Brisbane Central Business District Bicycle User Group

This letter concerns the area where the Bicentennial Bikeway crosses Archer Street in Toowong and the immediately surrounding areas.

Dr Richard Bean
Co-convenor
Brisbane CBD BUG
7 July 2014

Picture of where Bicentennial Bikeway crosses Archer Street, Toowong

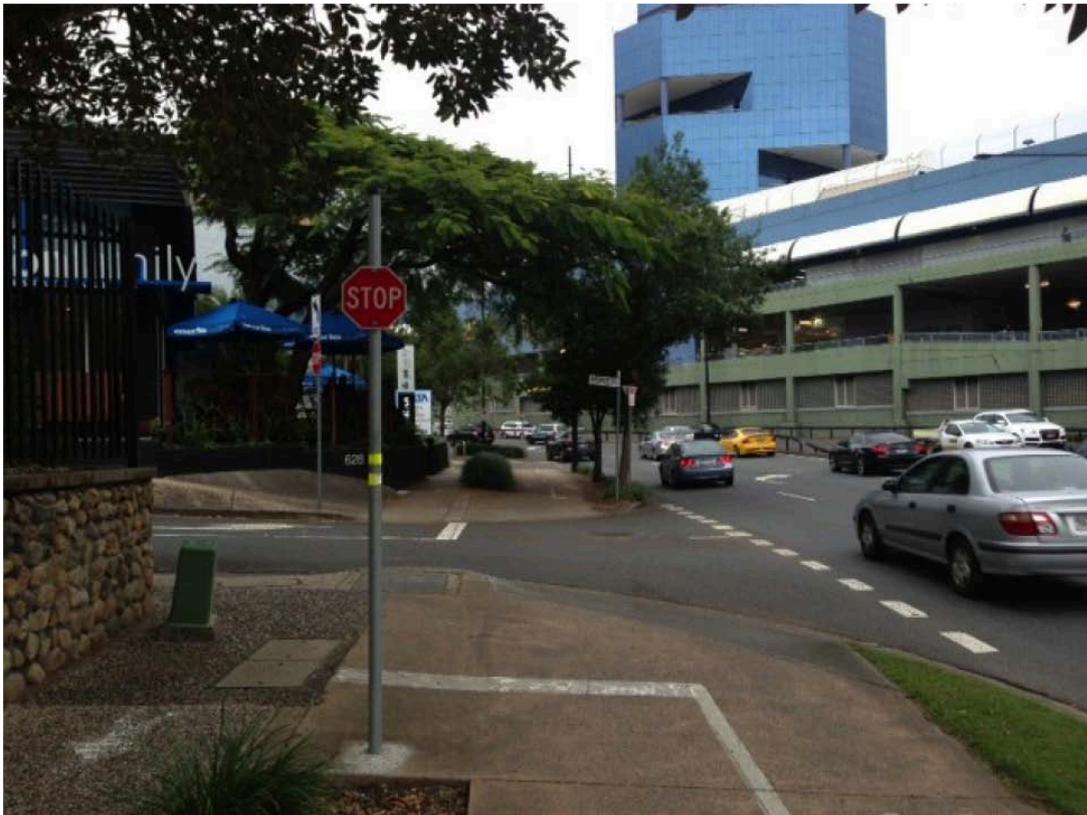
At this point on the Bicentennial Bikeway, cycling traffic heading away from the city faces a Stop sign.

Cyclists almost universally ignore this stop sign, if they even notice it at all, as it is inconvenient to stop at this point and the situation seems analogous to Rules 72 to 75 of the Queensland Road Rules whereby traffic turning left should give way to pedestrians crossing. (In reality, these are some of the least known sections in the Road Rules.) Turning traffic also has to cross a give way line. The speed limit on Coronation Drive at this point is 60 km/h and the speed limit on the local street, Archer Street, is 40 km/h. The speed limit on the next street to the left, Glen Road, is also 40 km/h.

- bicycles inbound have a give way sign, yet bicycles outbound have a stop sign.
- motorists exiting Archer Street have a stop sign also
- motorists have a give way marking before entering Archer Street from Coronation Drive
- there is no requirement for pedestrians to stop at all (which makes the bicycle signs all the more confusing).

There are many possible solutions to the cyclist priority problem. We would like to see a redesign which removes the stop sign and give way sign (on the other side of Archer Street) for cyclists.

- switching the bikeway and the footway so that the bikeway is further away from the street
- raising the bikeway across Archer Street and providing a coloured treatment to give implicit priority to bikes

- Queensland road rule changes and signage to make it explicit and clear that traffic turning left from Coronation Drive must give way to bike traffic
- Forbidding motorized traffic turning left at this point, possibly by the use of a bollard, and making motorized vehicles turn left at Glen Road instead – the speed of cars turning left there is generally lower; making Archer Street one way

Figure b—Public realm

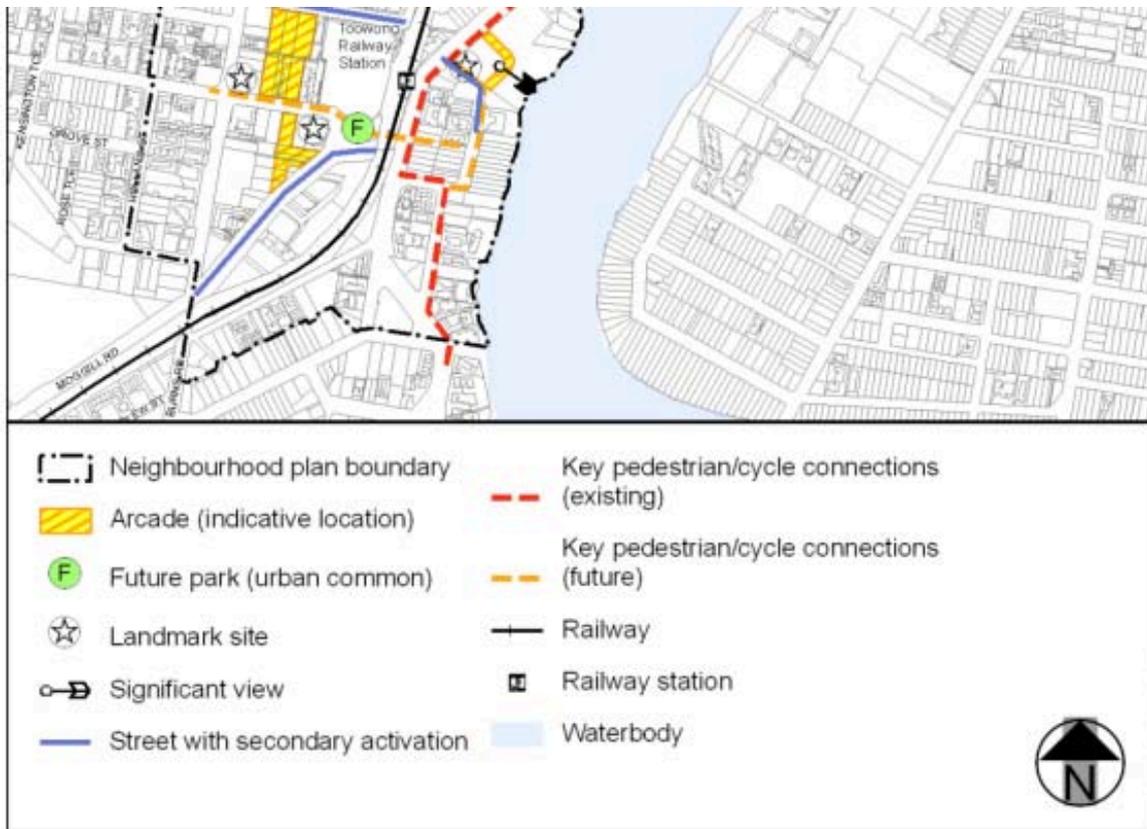
Archer Street is marked as a “future key pedestrian/cycle connection” (see figure from Plan).
